GUAM WATERWORKS AUTHORITY

Design-Build of GWA Upper Tumon Warehouse Renovation GWA Project No. 42102, IFB-01-ENG-2025 GWA Response to Request For Information (RFI) No. 1

EXHIBIT 'B'

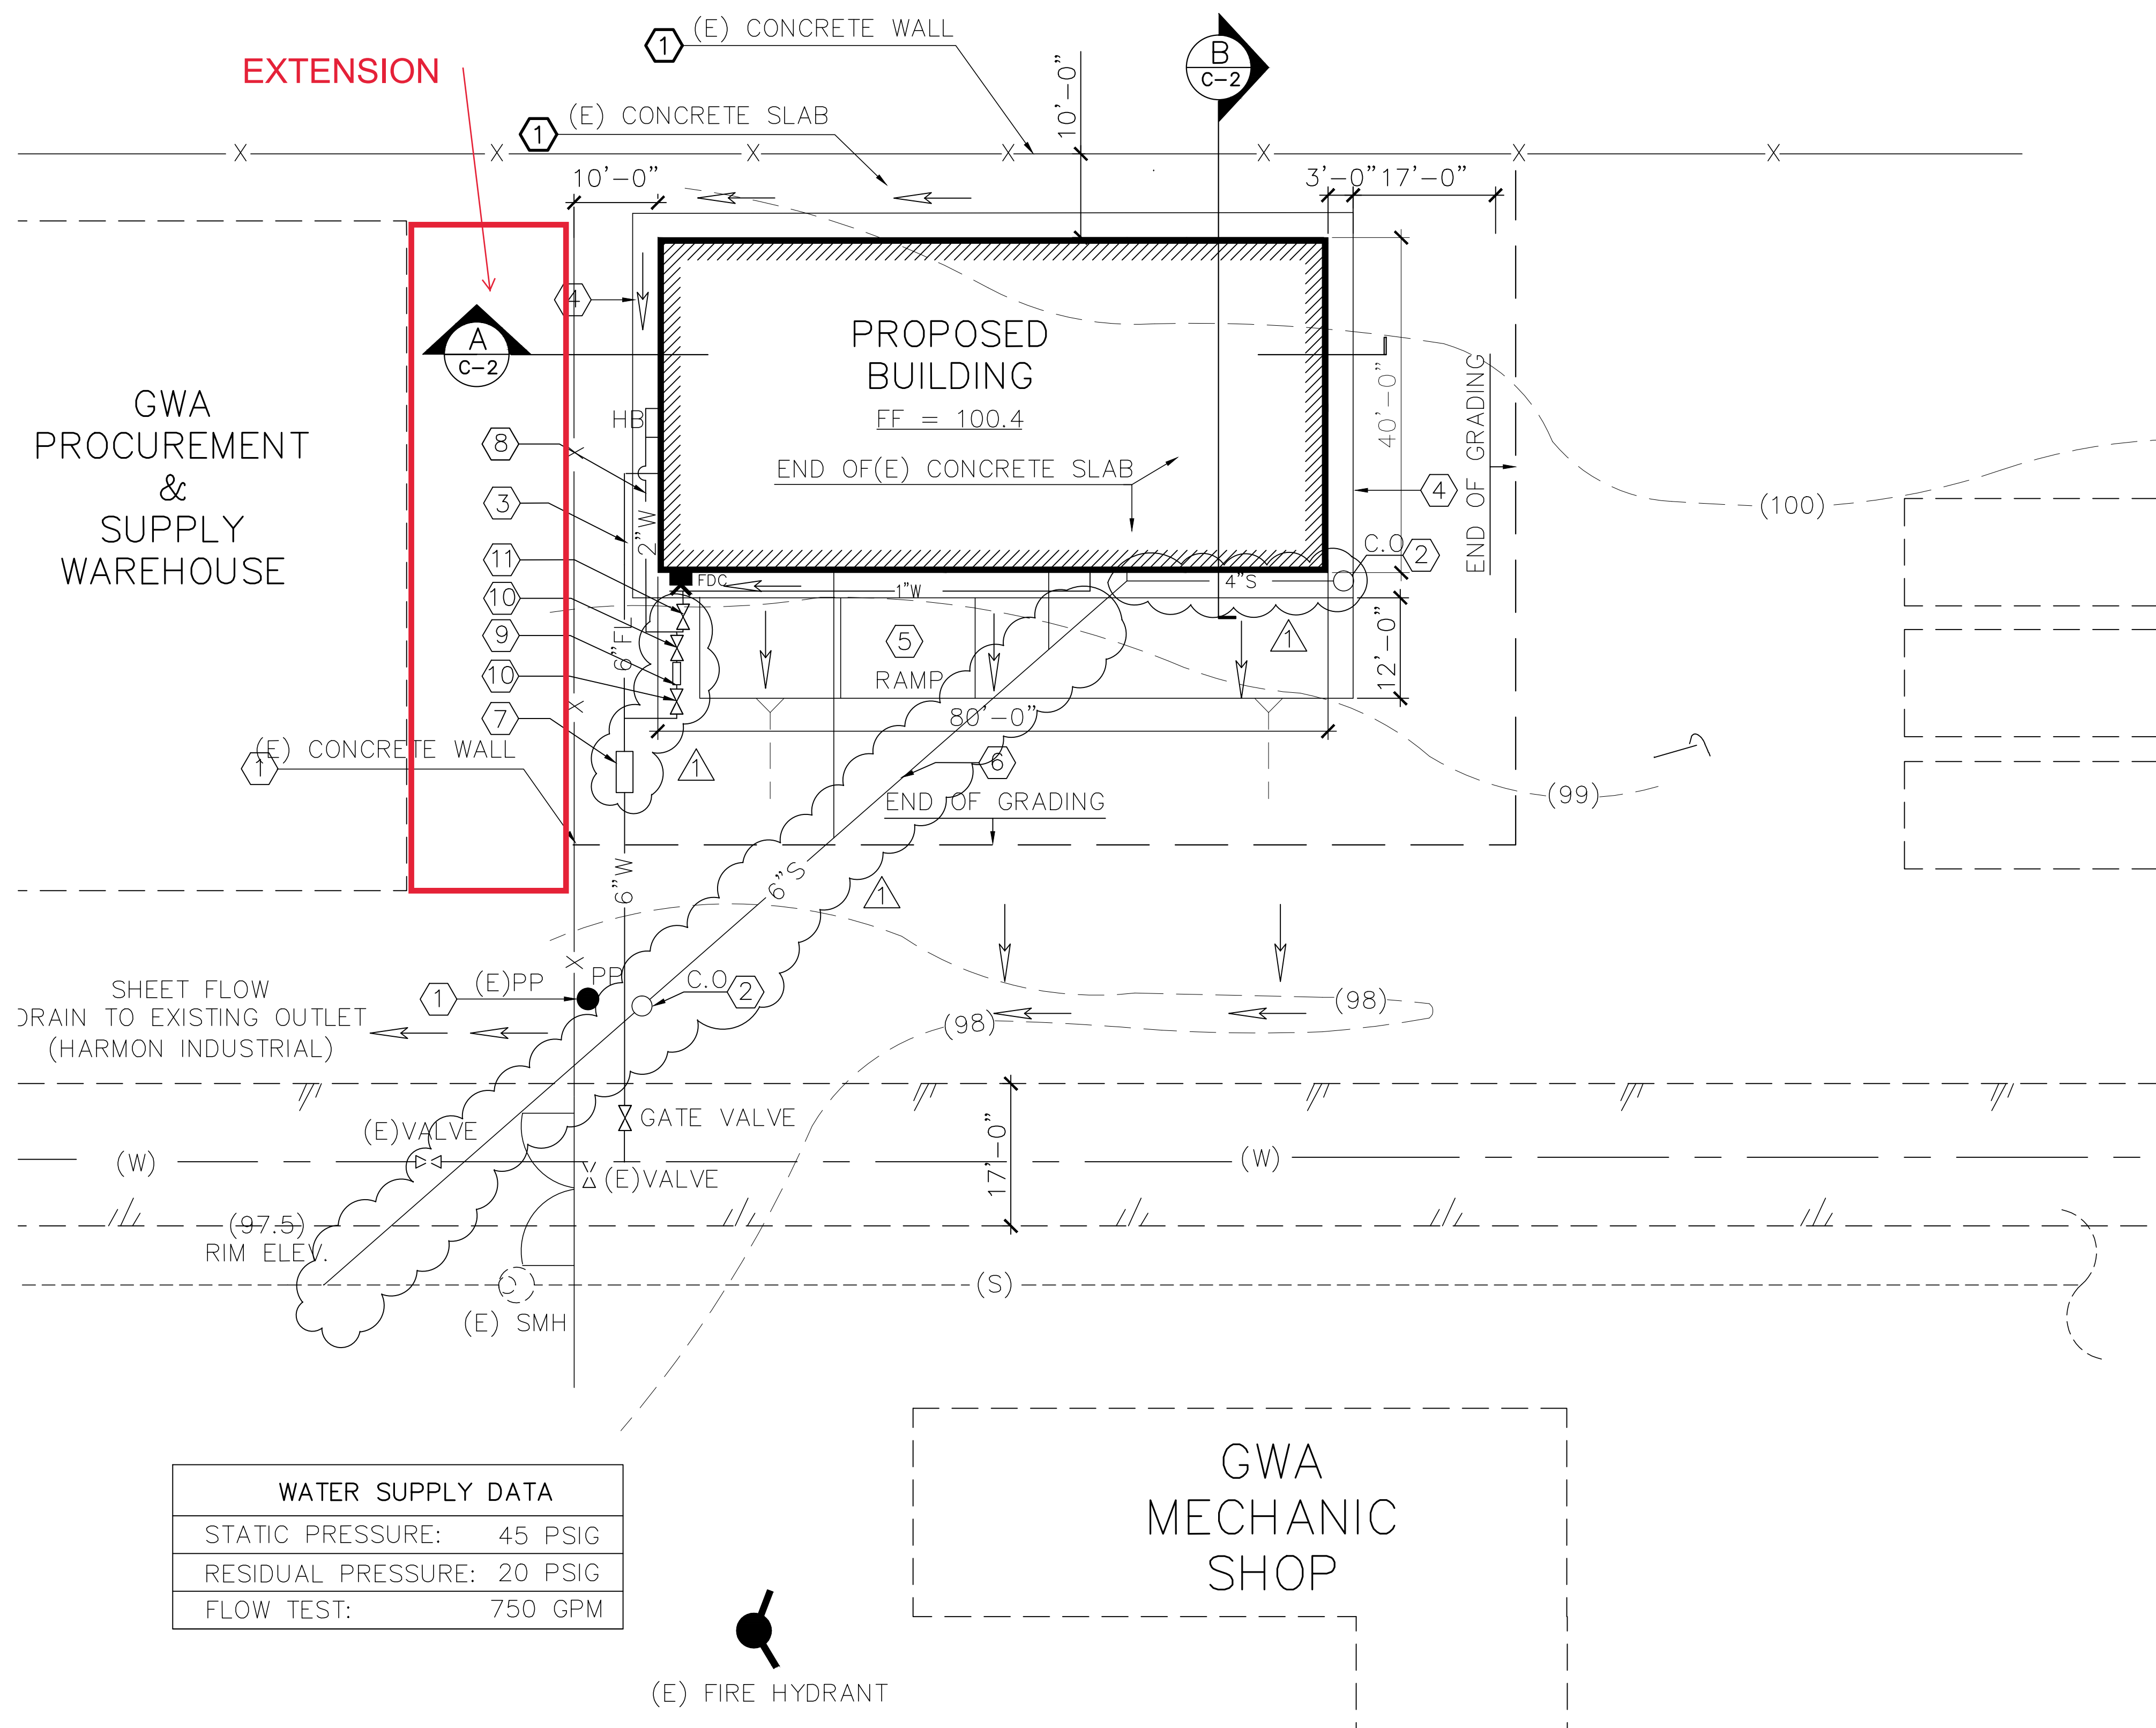
21	1/21/2025	Please label the new room names for reference and code evaluation	<i>Descriptions/room numbers are indicated on revision 1 drawings to be issued through an addendum.</i>
22	1/21/2025	Please confirm that no Site work or Site Utilities work is in this scope of work	<i>The water/sewer service for the warehouse extension can be connected existing water and sewer lines. Refer to Exhibit "B" of the Attachments.</i>
23	1/21/2025	Please provide a site plan showing the distances from the building to property lines and buildings immediately adjacent to the existing building. This is necessary to determine the if fire ratings are required at existing walls and openings, and that the new stairs are not located in a non-conforming area.	<i>Refer to Exhibit "C" of the Attachments.</i>
24	1/21/2025	It appears that the first floor "office" areas are being provided air conditioning via split units. Since no air conditioning is in the scope of work, please describe how required fresh air is provided to those spaces.	<i>Bid item 7.7 is for the Supply and installation of ACCU at all office rooms (Ground Floor and Mezzanine Floor).</i>
